**GE Nuclear Energy**

GE-NE-0000-0002-9600-01R2a  
DRF 0000-0028-4024  
Revision 2  
Class I  
May 2004

**Pressure-Temperature Curves  
For  
Exelon  
Dresden Unit 3**

Figure 3.4.9-1 (Page 1 of 1).  
Non-Nuclear Inservice Leak and Hydrostatic Testing Curve  
(Valid to 32 EFY)

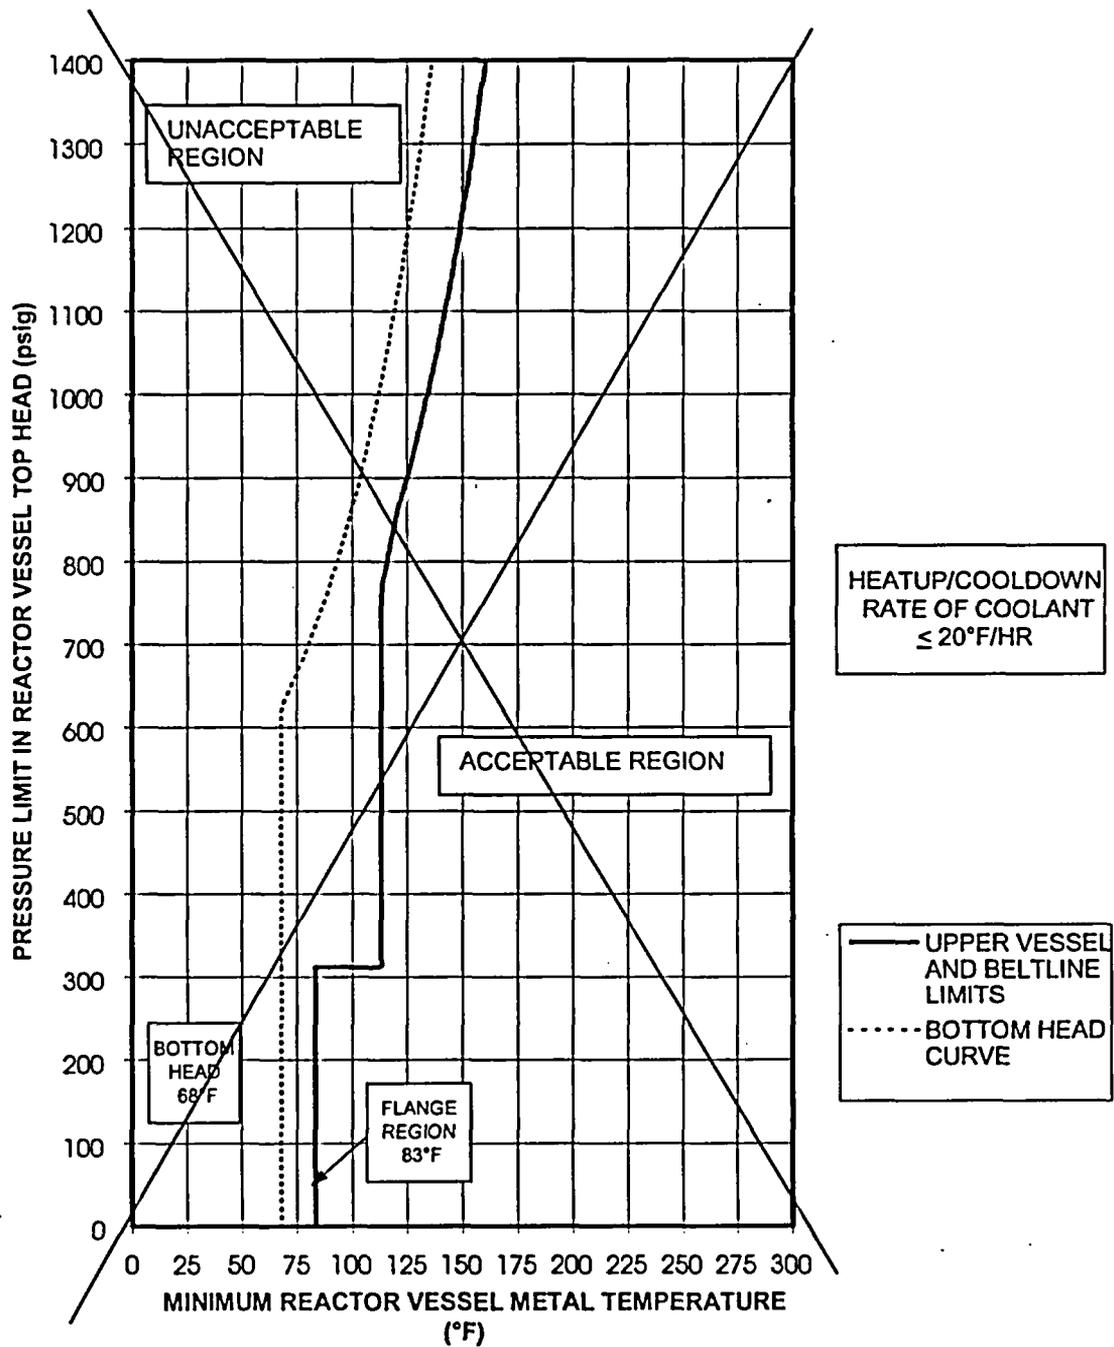
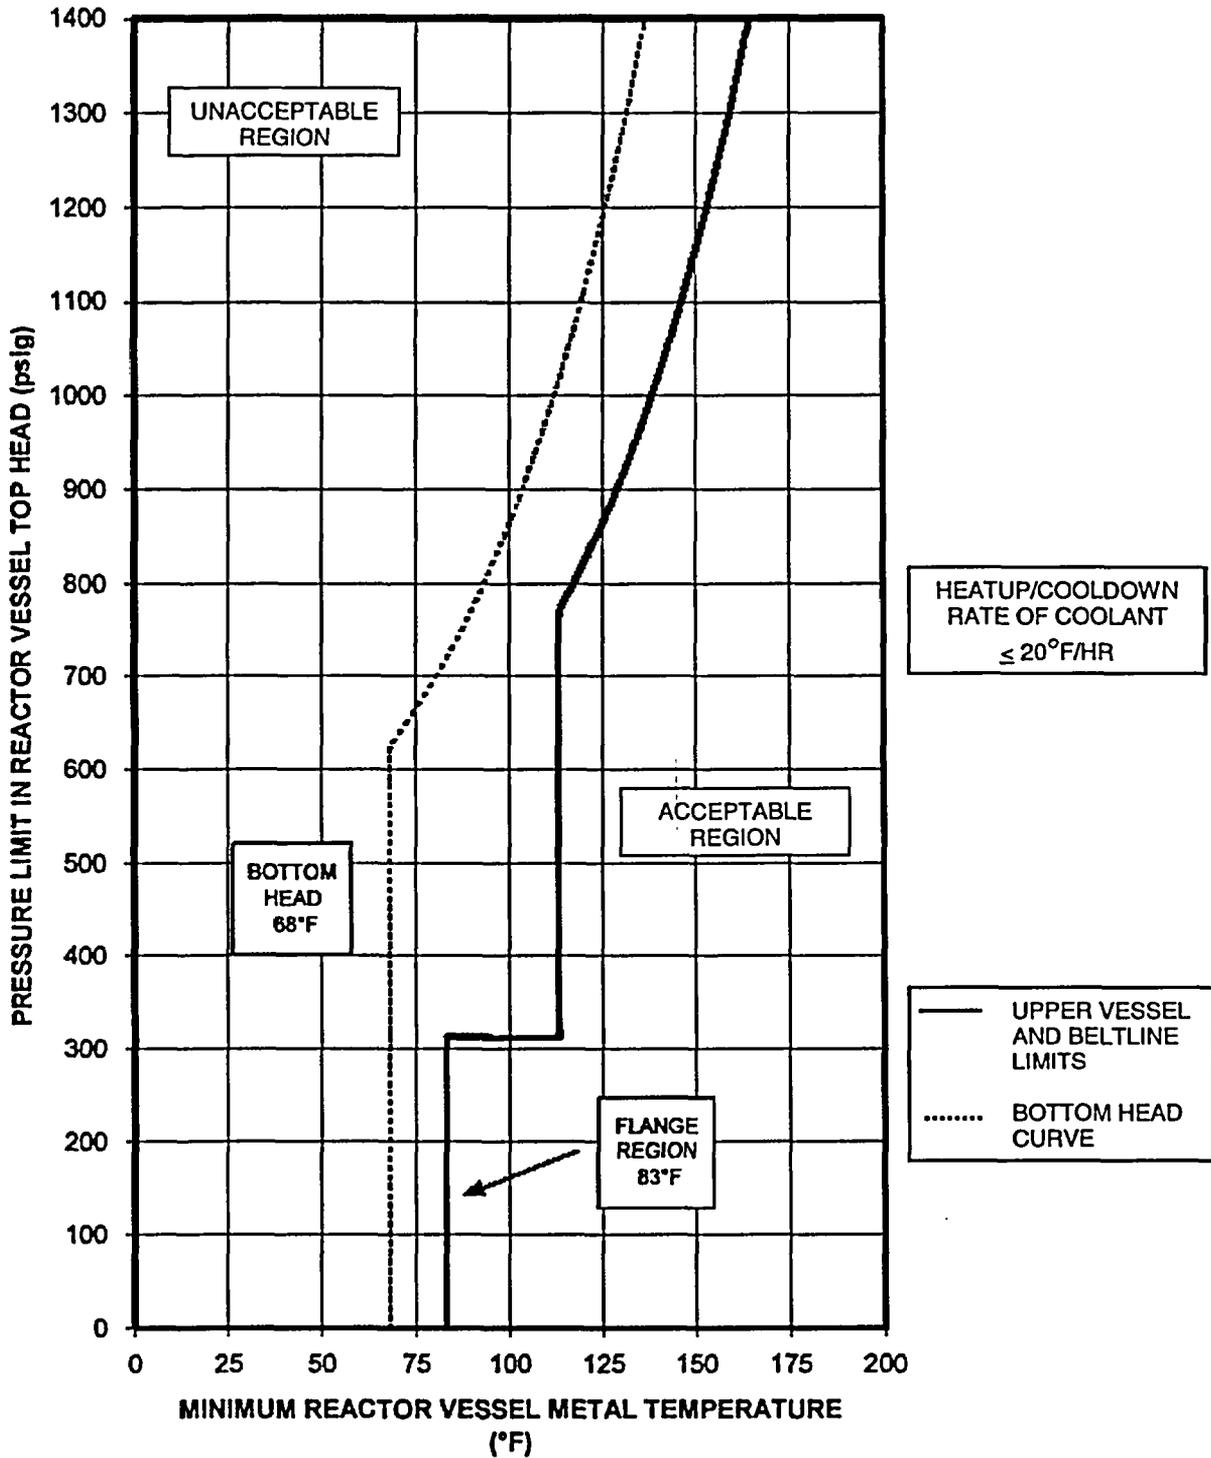
- Replace the current TS Figures 3.4.9-1, 3.4.9-2, and 3.4.9-3 with revised TS Figures 3.4.9-1 through 3.4.9-3. The revised P/T curves are applicable to 54 effective full power years (EFPY) as determined for a 40-year license with a 20 year renewed period.

54

Figure 3.4.9-1 (Page 1 of 1)  
Non-Nuclear Inservice Leak and Hydrostatic Testing Curve  
(Valid to 54 EFPY)

Figure 3.4.9-2 (Page 1 of 1)  
Non Nuclear Heatup/Cooldown Curve  
(Valid to 32 EFY)

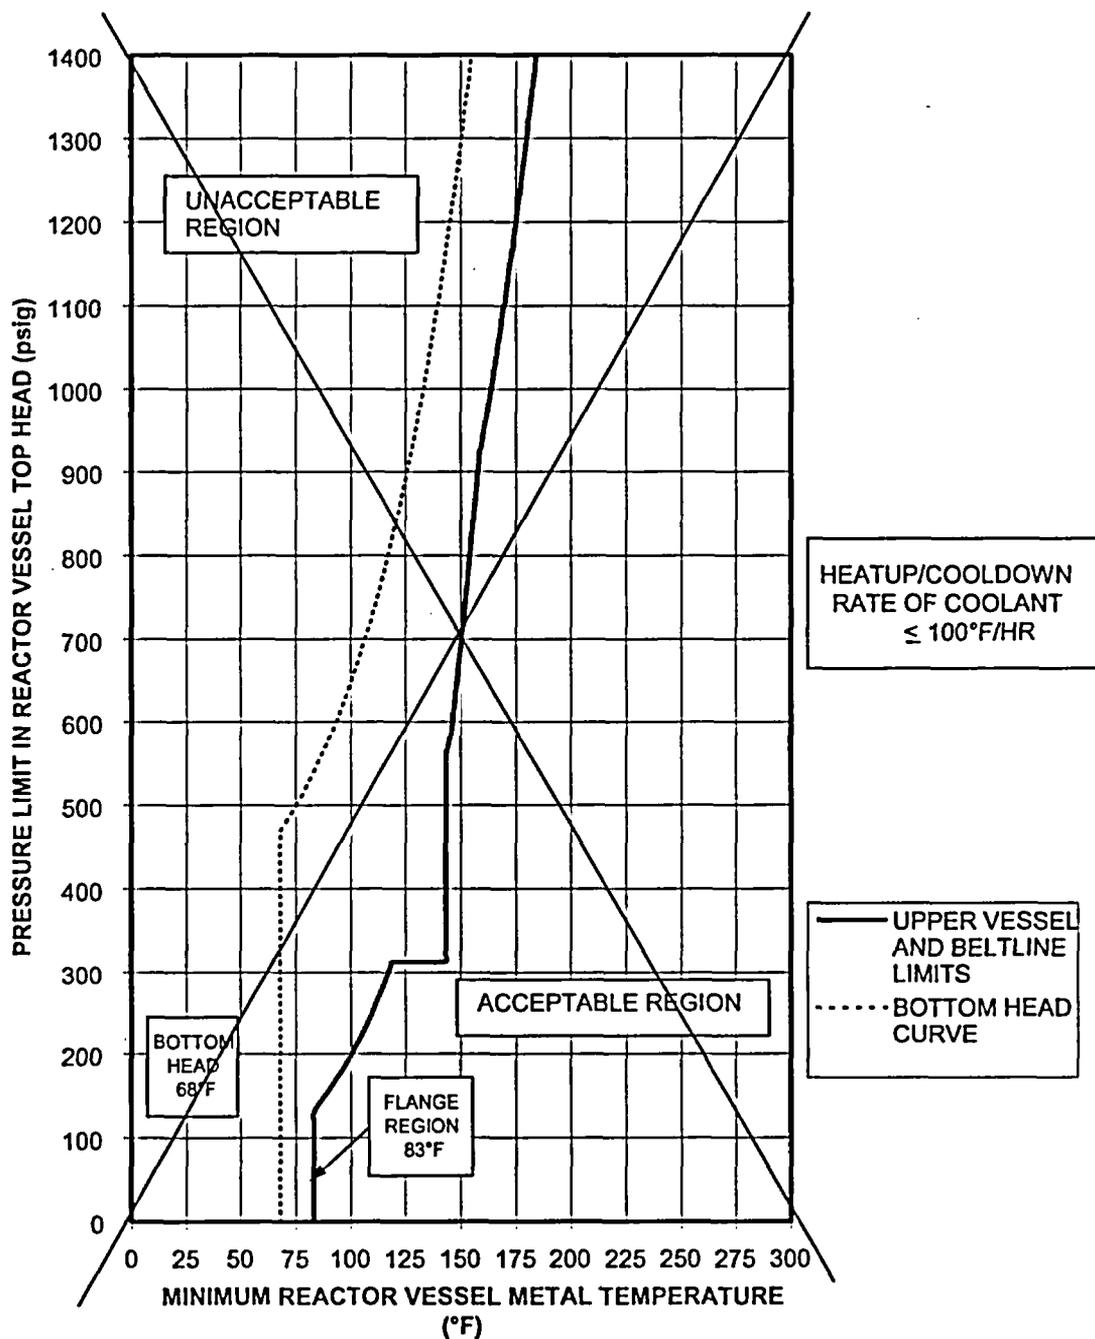
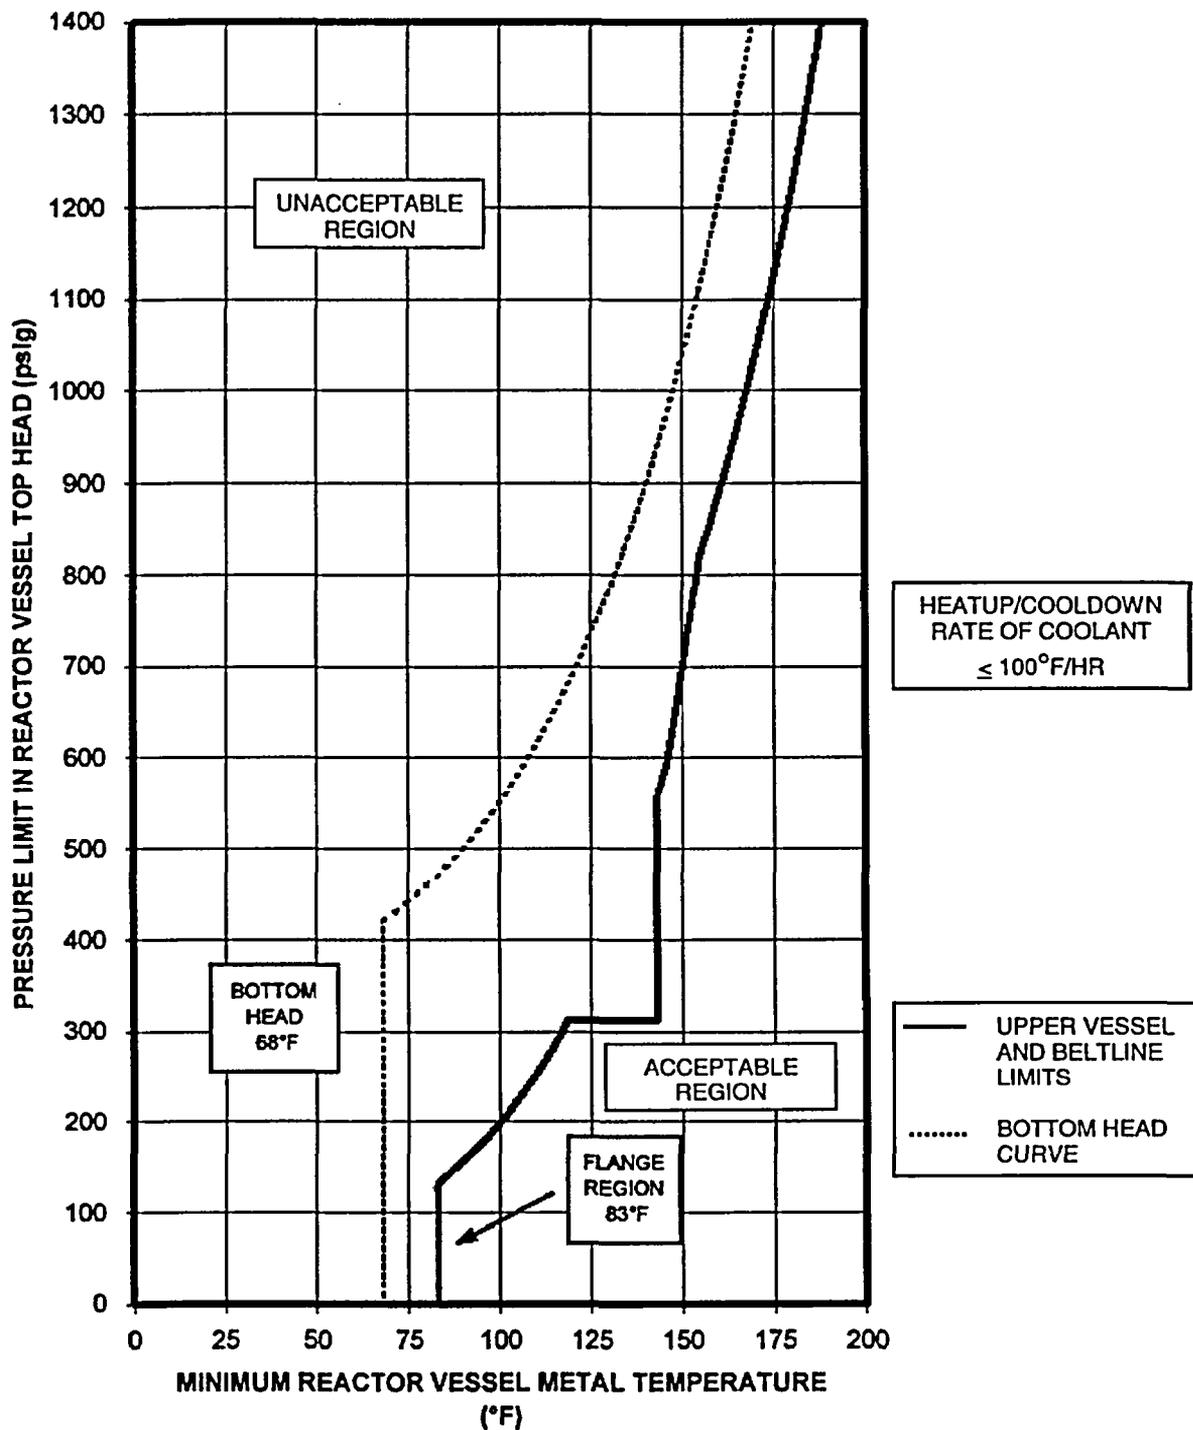
An evaluation was performed using plant specific inputs to scale the stresses for the limiting normal and upset thermal transients, which determined that the bottom head region of the non-nuclear heatup/cooldown curve was non-conservative for QCNPS. Specifically, the current P/T curve for the reactor pressure vessel bottom head region of Figure 3.4.9-2, "Non-nuclear Heatup/Cooldown Curve," was determined to be non-conservative by 14.6 degrees Fahrenheit (°F) for QCNPS Unit 1 and 11.6°F for Unit 2 during a bounding anticipated operational occurrence for the improper start of an idle recirculation pump, which is more severe than the normal upset condition (i.e., loss of feedwater transient). Since the P/T limits are established considering the safety factors of ASME Section XI, Appendix G, this non-conservatism in the region of the bottom head curve implies that a safety factor of two may not be maintained if the plant is conducting operations with the RPV bottom head pressure and temperature near the existing curve in TS Figure 3.4.9-2.

54

Figure 3.4.9-2 (Page 1 of 1)  
Non-Nuclear Heatup/Cooldown Curve  
(Valid to 54 EFPY)

Figure 3.4.9-3 (Page 1 of 1)  
Critical Operations Curve  
(Valid to 32 EFPY)

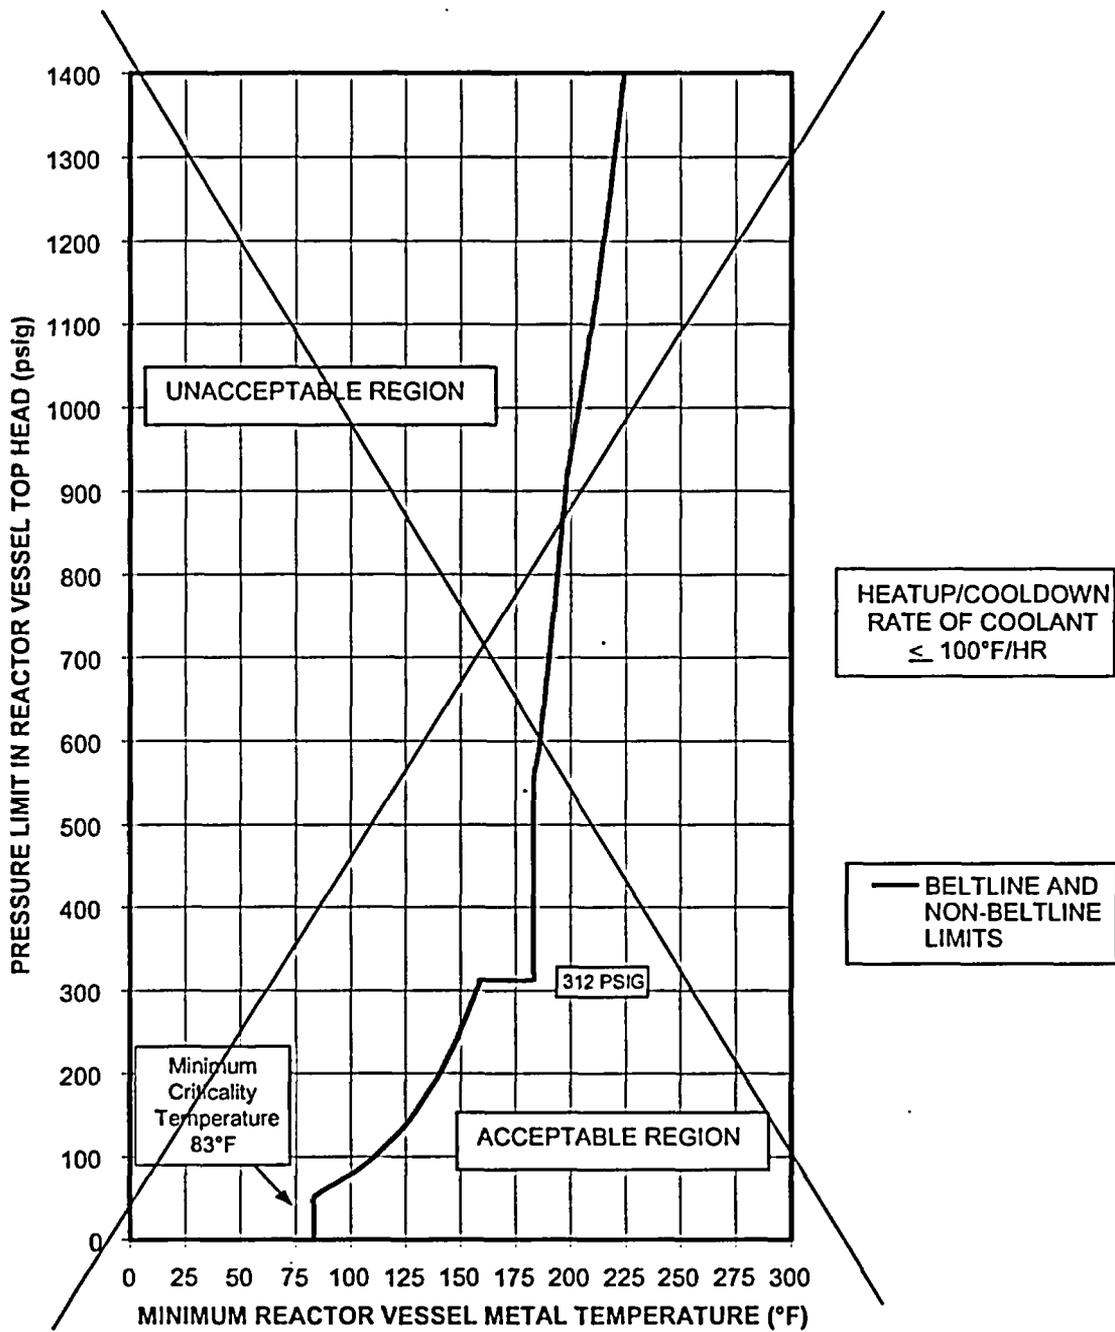
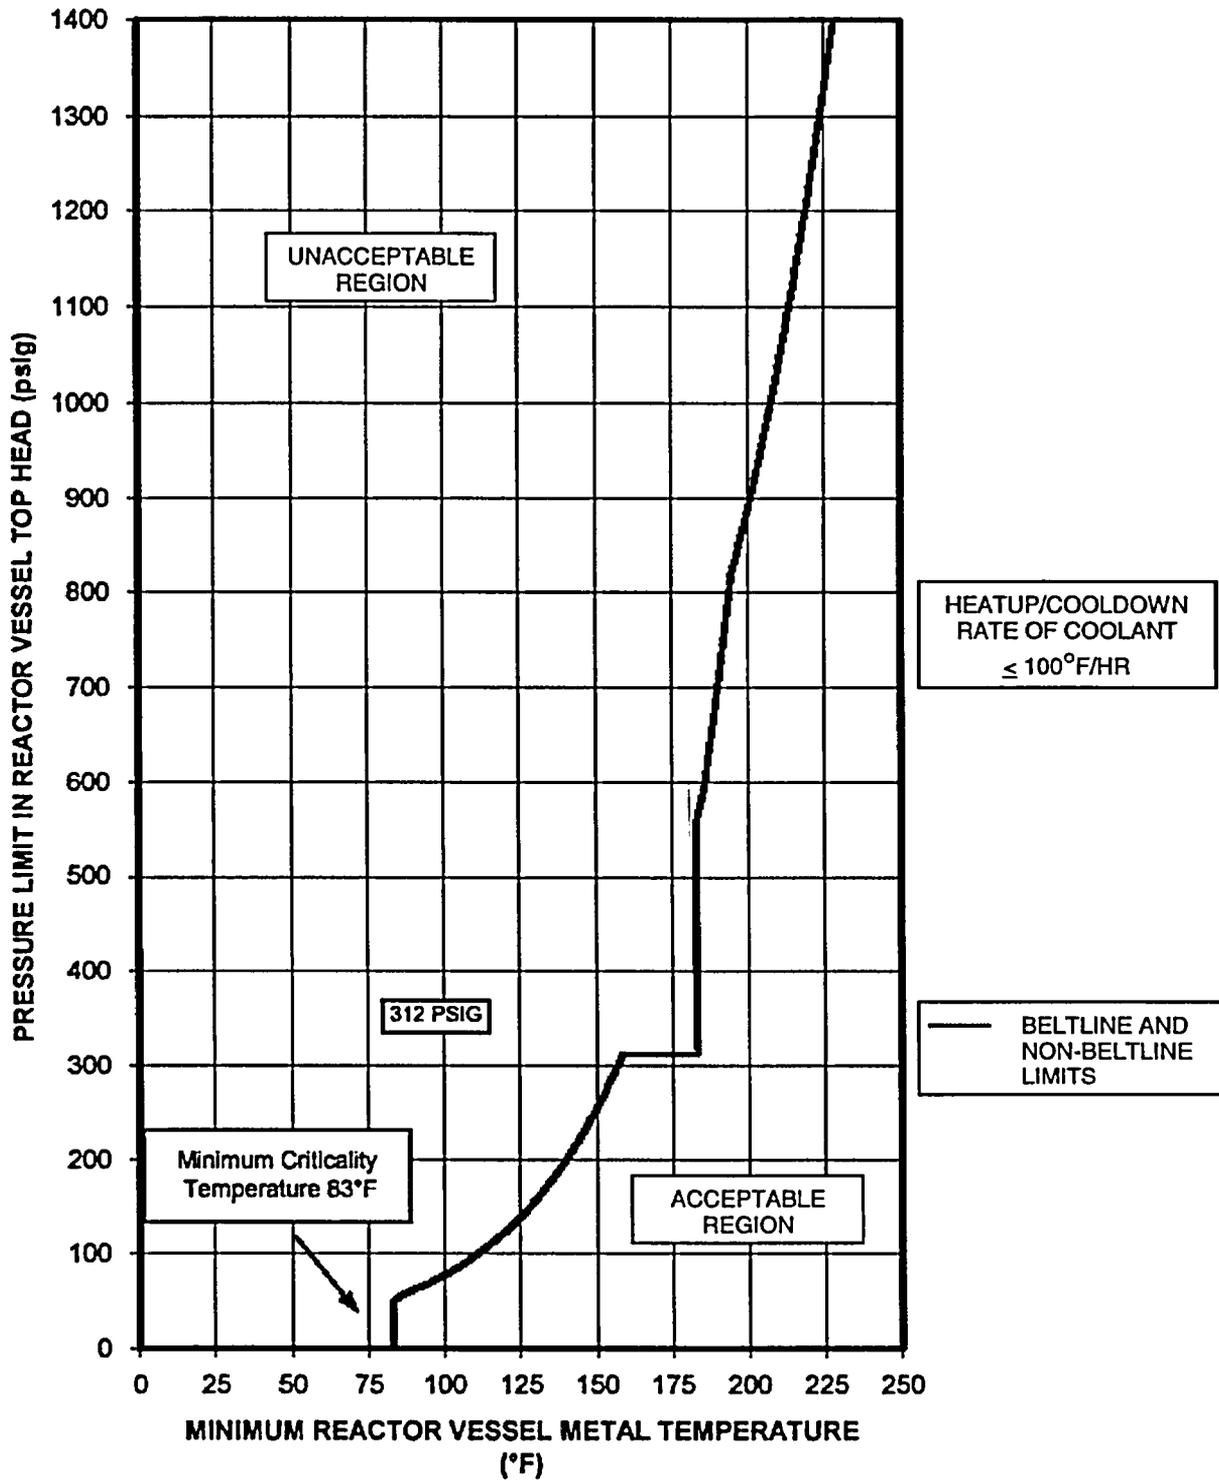
54

Figure 3.4.9-3 (Page 1 of 1)  
Critical Operations Curve  
(Valid to 54 EFPY)
